Traffic Control Devices Order, amendment

Regulation 157/2014
Registered May 28, 2014

Manitoba Regulation 264/88 amended

Sunday/Holiday Bicycle Route Street Closure sign (MR-178 and MR-178F)

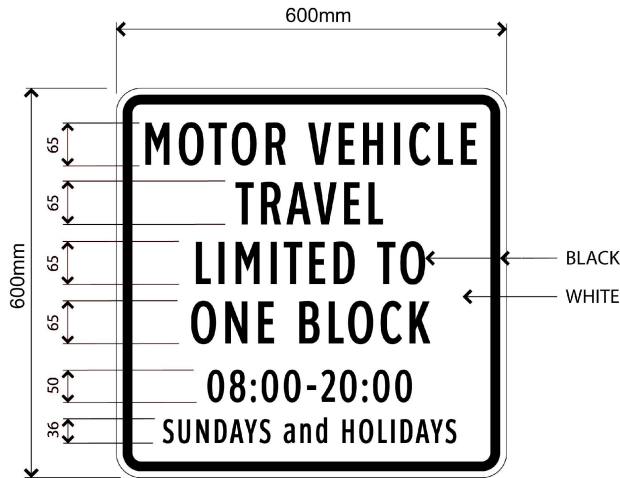
2 **Section 65.25 of the Schedule is replaced with the following:**

65.26(1) A “Sunday/Holiday Bicycle Route Street Closure” sign MR-178 or MR-178F may be used to indicate to drivers

- (a) that motor vehicle travel is limited to one block on a designated Sunday/Holiday Bicycle Route; and
- (b) the hours of the day and days of the week when the motor vehicle travel is limited.

65.26(2) A “Sunday/Holiday Bicycle Route Street Closure” sign MR-178 must

- (a) be square in shape;
- (b) be not less than 600 mm in width and 600 mm in height;
- (c) be white in colour and
 - (i) in the upper portion, display the words “Motor Vehicle Travel Limited To One Block” in black upper case letters not less than 65 mm in height,
 - (ii) in the bottom portion, display
 - (A) the time of day in black numerals not less than 50 mm in height, and
 - (B) the words “Sundays and Holidays” in black upper case and lowercase letters not less than 36 mm in height;
- (d) be available in a French version as shown in the illustration labelled “MR-178F”;

(e) be reflectorized to show the same colour and shape by night as by day; and

MR-178

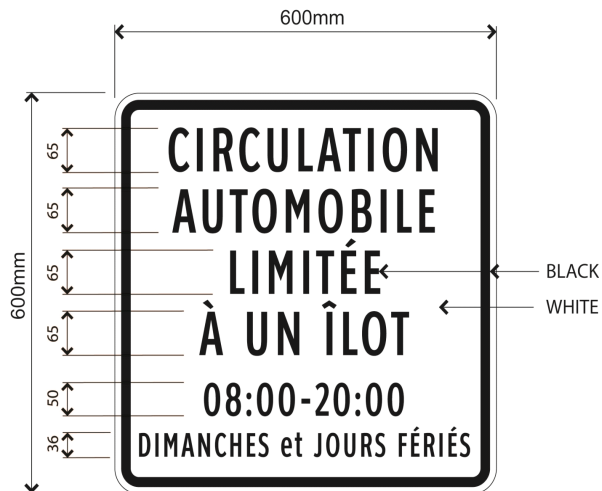
(f) bear the markings and have the dimensions illustrated in either of the following illustrations:
